Objections to the Bernhardt Application

Re: Bernhardt Sand and Gravel Pit, File No. M-2023-025, 112 Construction Materials Reclamation Permit Application, Notice of Objection Letters Received

Aerial photos from 2014.

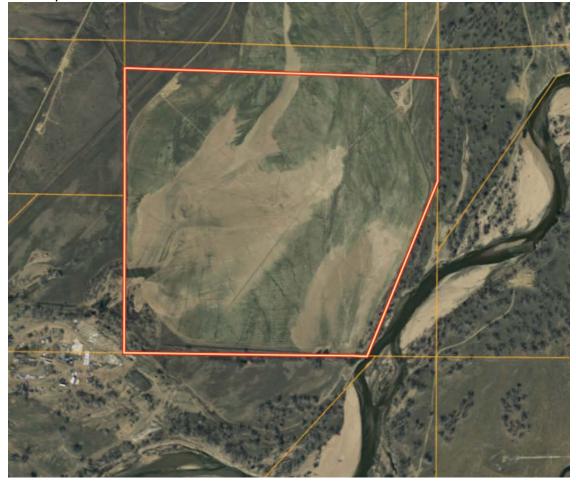
Flooding. Historically during flood events, water has flowed through my property 3. and into the proposed mining property. In recent years, it appears that a berm up to 10 feet in height in places has been constructed on the west side of the mining property. This will protect the mining property to the detriment of my property and surrounding properties since the farmland historically used to accommodate flood volumes will no longer be available. See attached aerial from June 2014 showing evidence of a deep cut on the west side of the mining property and evidence of erosion and deposition across most of the mining property. Floodwaters have been carried through an irrigation channel that has not been in use for years. Head gates still remain on my property that the berm had been built after 2013. The other split in the water flow the canal between my property and the proposed mining operation that carried the water to the Platte River since has been filled with trees and other debris, which could leave my property vulnerable as the flow of water that leaves my property at the high flood area, I think the building of the berm that let the water flow across the mining property, and the fact that the old canal along the property line has been filled with trees and other debris that could lead to a High water situation that could be detrimental to not only my property but to the surrounding properties as well. This picture was taken after the flood event in Sept 2013. Approximately 95% of the mining site is in the floodplain. How will the mining and reservoir affect the floodplain and flooding on my property?

I have attached a overhead view showing the berm installed in 2014 the highlighted yellow shows the drainage canal
